FINAL REPORT

DESIGN PROOF CHECK

SPPL DEMO PROJECT

Sanrachna Prahari Pvt Ltd

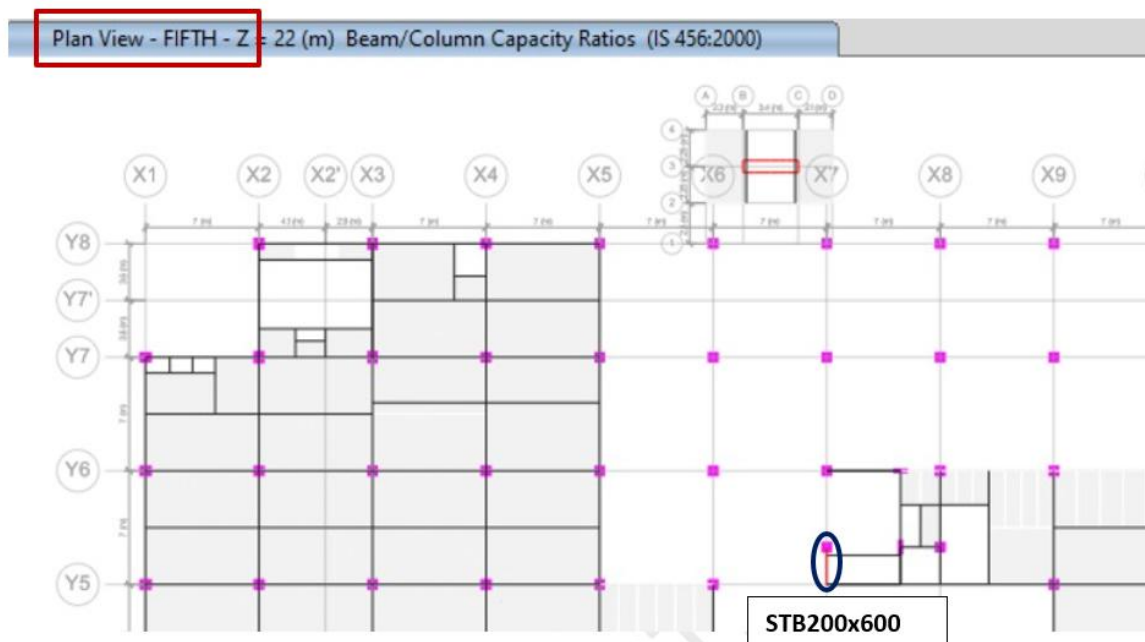
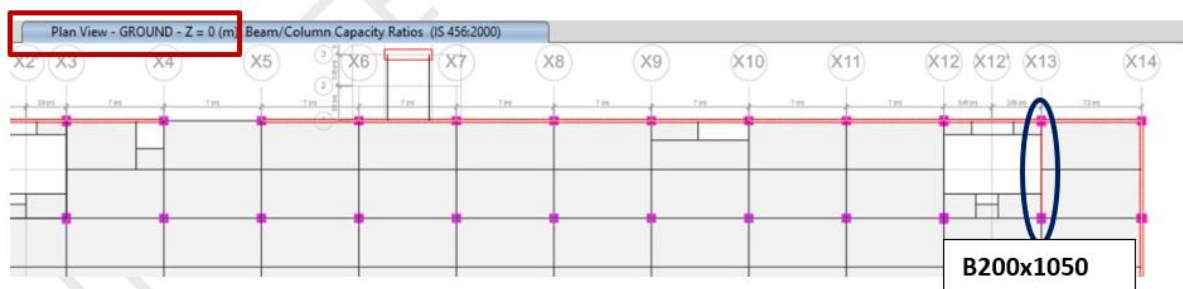
1. Reference –
 - a) Meeting with client design team representatives
 - b) Email from Client (RE: A2 Project (Demo) at New Delhi- Proof Check of Structural design works)
2. Beams at different levels have issues, as mentioned against each in the table below: -

<u>Level</u>	<u>Type of member</u>	<u>Remark</u>
Ground	B200x1050	Shear stress due to shear force and torsion together exceeds maximum allowed
Fifth	STB 200x600	Shear stress due to shear force and torsion together exceeds maximum allowed
Roof -2	B250-450 MB	Reinforcing required exceeds maximum allowed
Roof -2	B250-600 MB	Shear stress due to shear force and torsion together exceeds maximum allowed
